AGENDA
PLANNING COMMISSION REGULAR MEETING
Wednesday, March 15, 2023, at 6:00 PM

1. Appointment of Chair and Vice-Chair
 - Legislative
 - Staff Presentation: Nicholas Wharton, Town Manager
2. Resolution PC-2023-02R: Ziggi's Site Plan
 - Legislative
 - Staff Presentation: Abdul Barzak, Town Planner

Date: 9.12.22 Resubmitted: 12.16.22, 2.7.23
 Project Name/Contact: Ziggi's Severance/Paul Bass (TST)
 Project Address: 9843 E. Harmony Road
 Customer/Project Number: 284 - American Eagle Properties attn. Jerry Helgeson
 Review Number: 3rd Submittal
 Project Coordinator: Abdul Barzak, Town Planner
 Recipients:

UTILITY PLAN

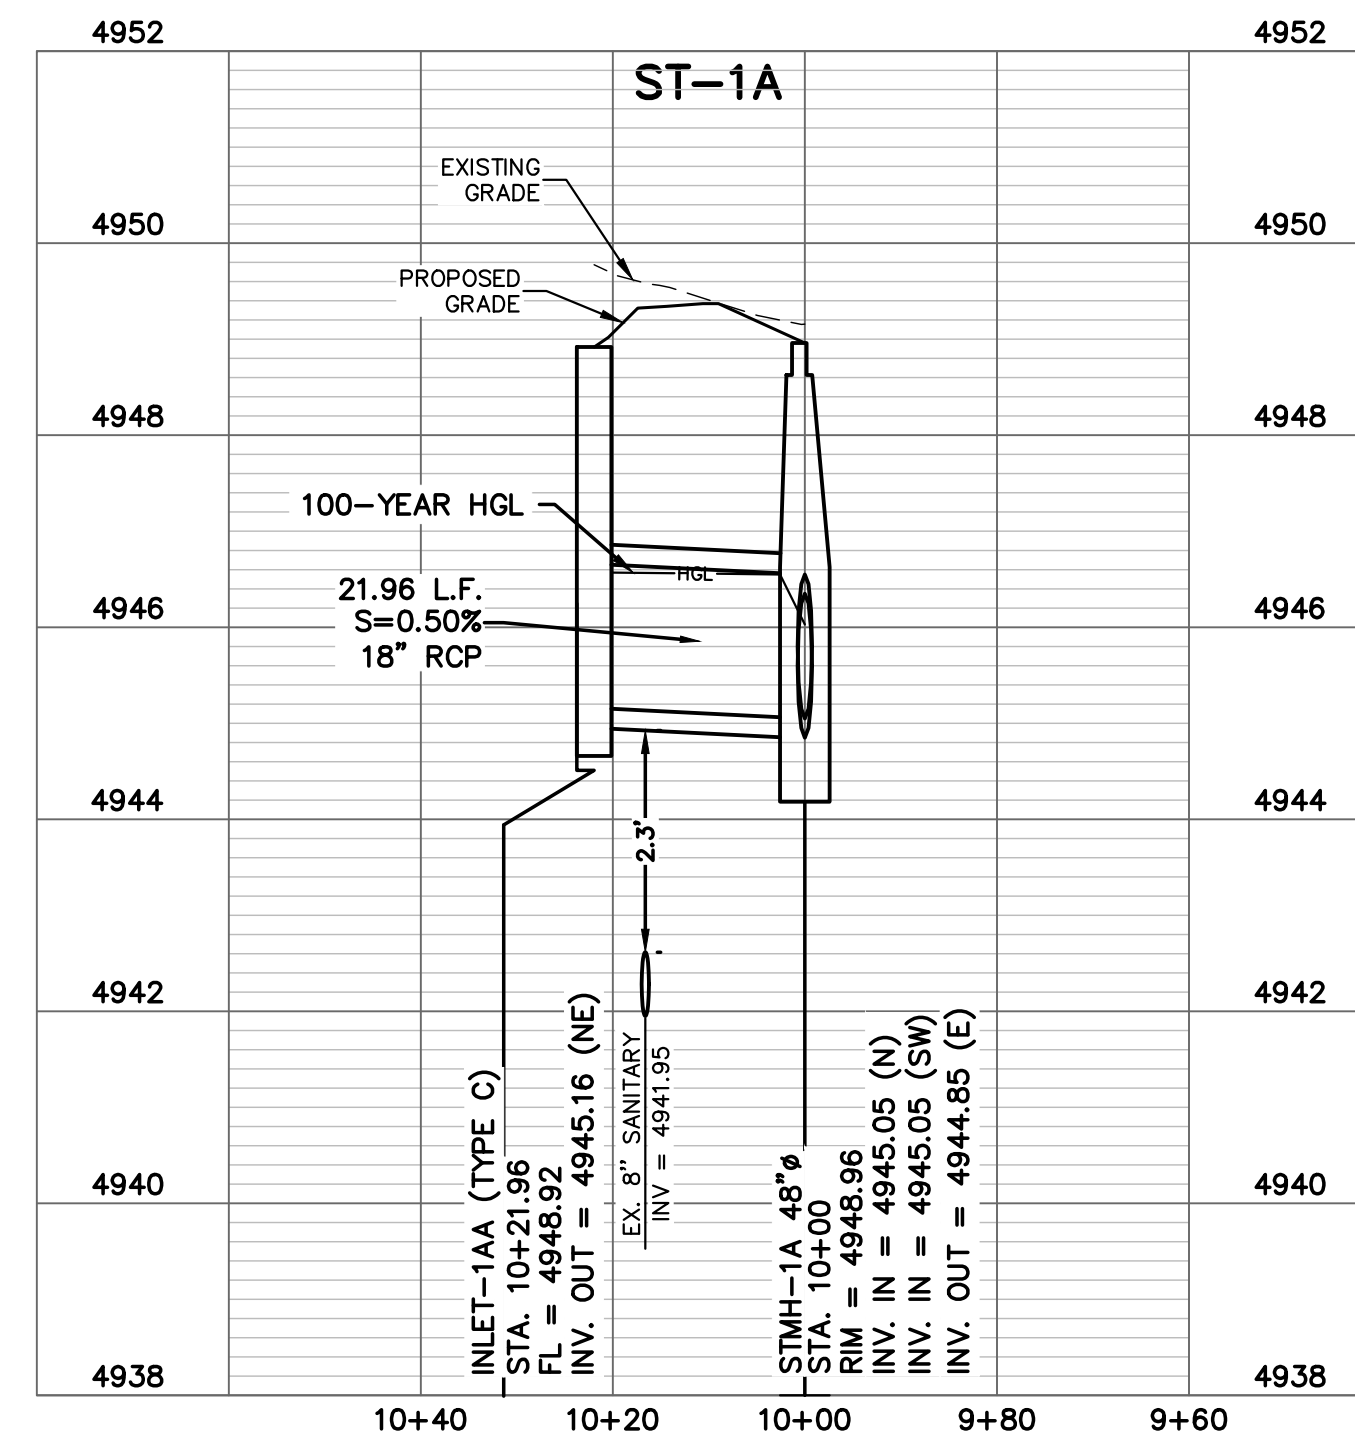
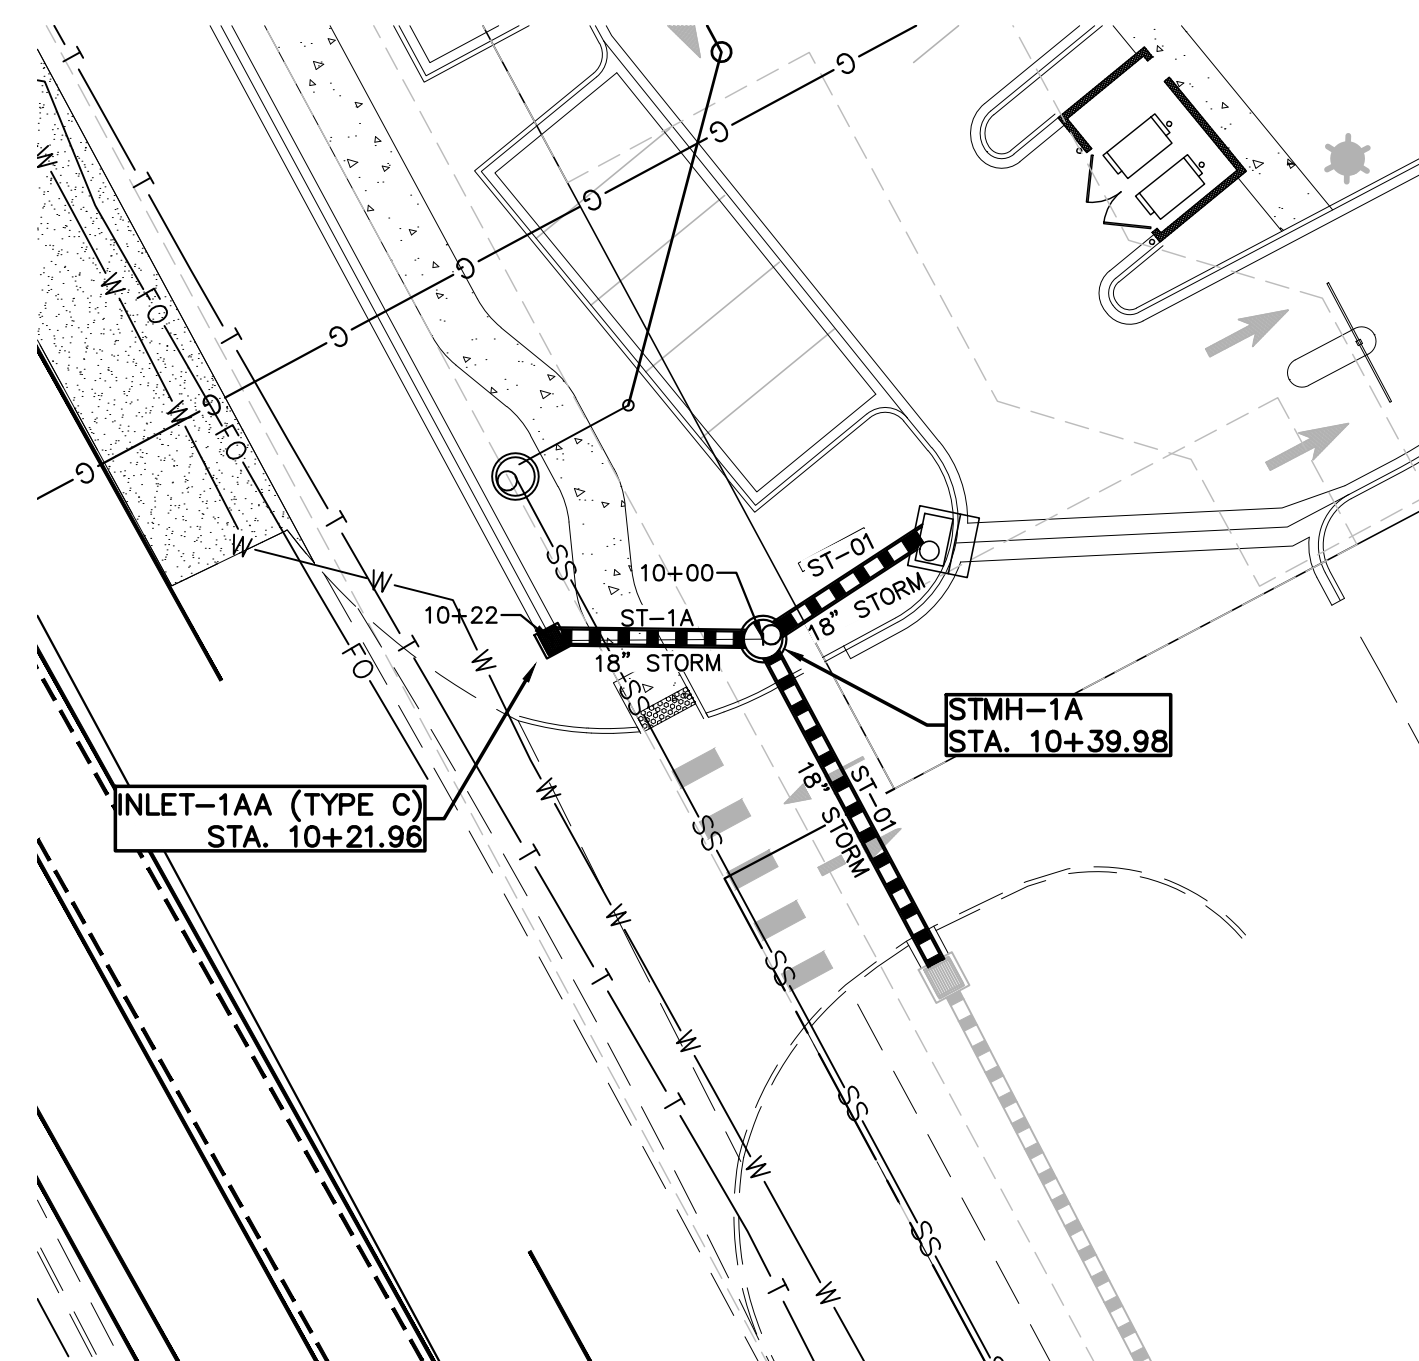
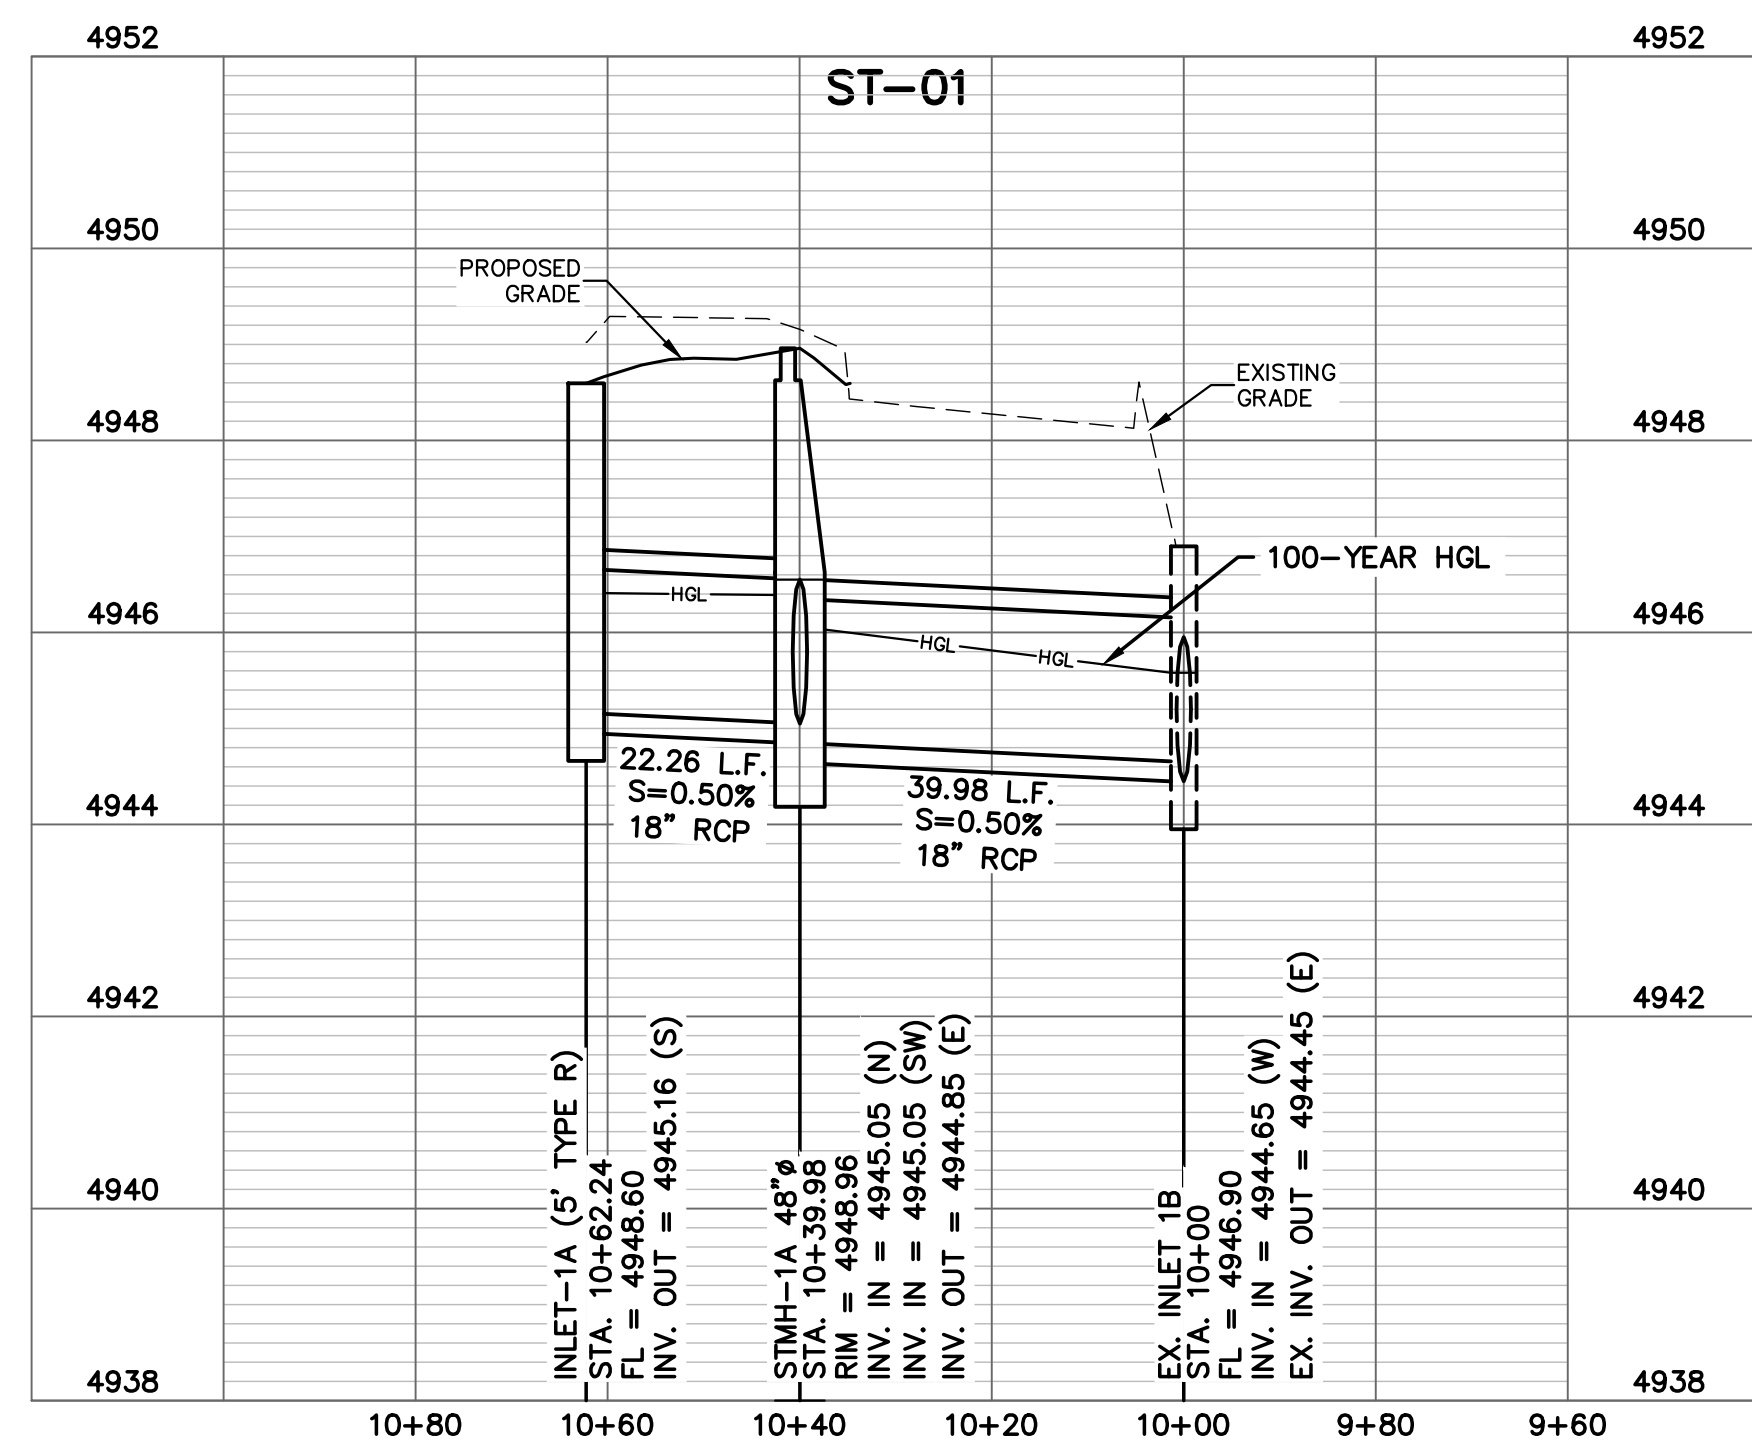
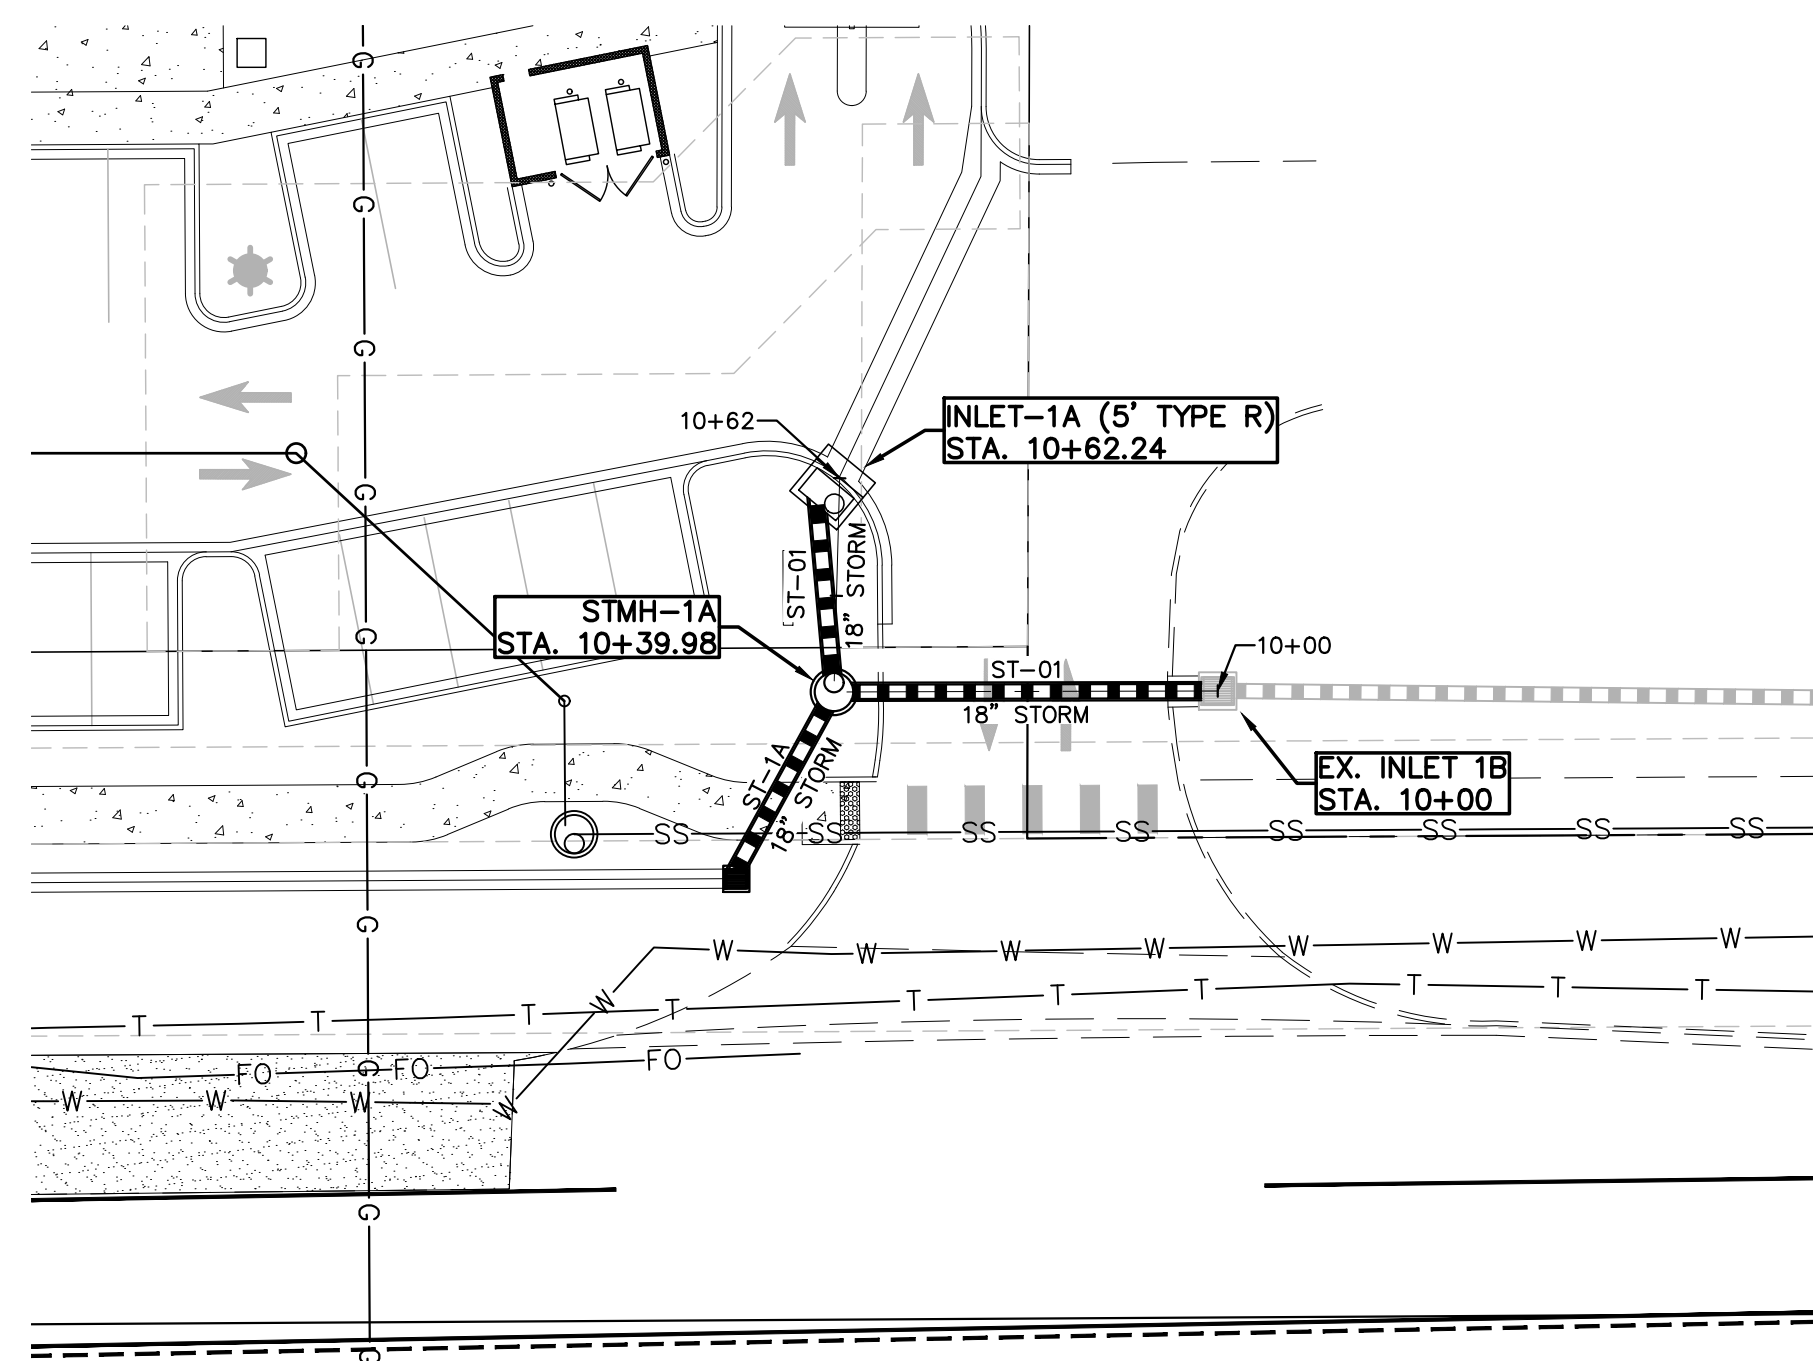
18. Sheet 6 (Utility Plan) – The plan shows a proposed 1.5-inch water service and meter and connection to the existing 4-inch sanitary sewer service stub-out. Utility connections are off utilities in E Harmony Rd (WCR 74).
